**THE ENFIELD CYCLE COMPANY LIMITED**

Broken Connecting Rod in Works  
"Interceptor"

750cc Twin Engine Connecting Rod.

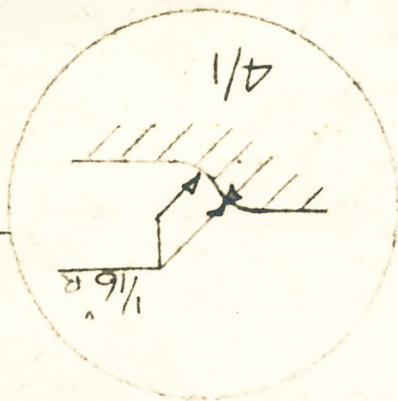
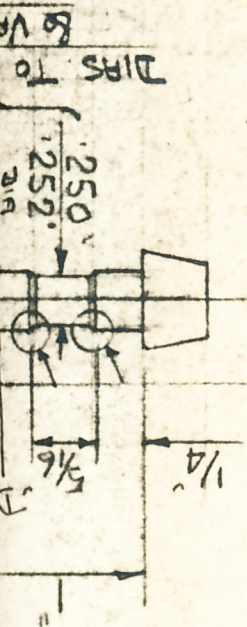
It would be quite practicable to leave the rod wider at the joint face as suggested, the increase in width amounting to about .135"

Nine Jigs and Fixtures would require the location altered, this would cost approximately £100. A milling fixture for the angle on side of rod would be required at a cost of approximately £40.

The shape of the rod would be as shown on sketch.

EXPERIMENTAL CONN. ROD BOLTS

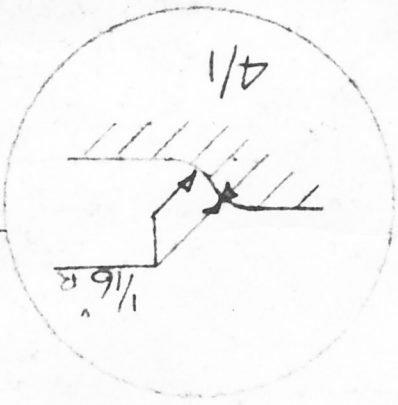
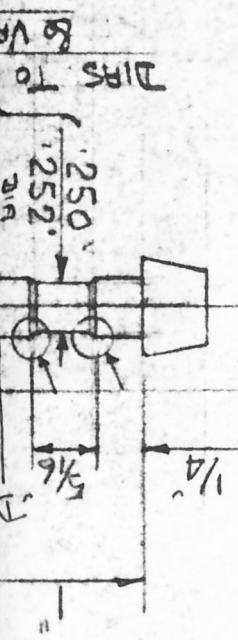
Messrs Bocker and Wilson-Jones are pursuing the matter further, meanwhile we are preparing 12 bolts to the enclosed drawing, made from the standard bolts, of which, we shall retain 6 and send 6 to Redditch for testing.
